Springdale Solar Farm

Response to Submissions Report

Client: RES Australia Pty Ltd

29-May-2020

Figure 7.1 Constraints map – Amendments

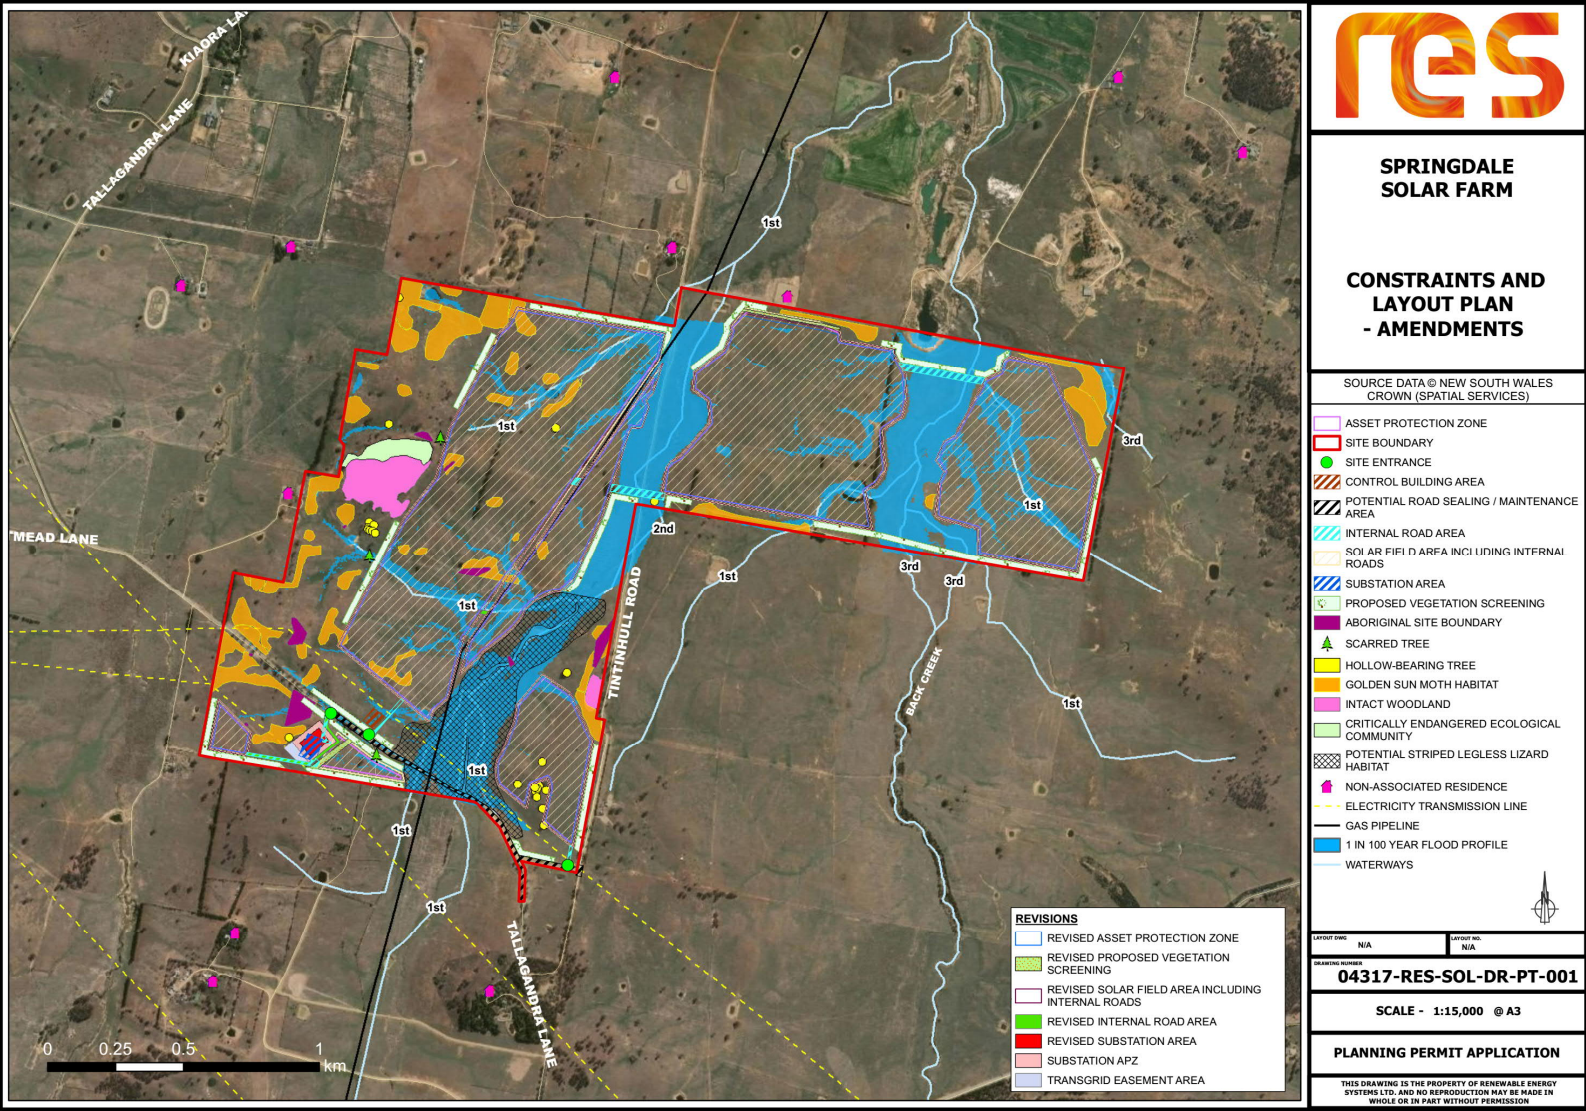
DPIE has requested that the proponent provide the following additional information in this RtS report:

Figure 7.1 shows the amendments made to the Project and constraints at the Site. Figure 7.2 shows the constraints at the Site. The figures include the following:
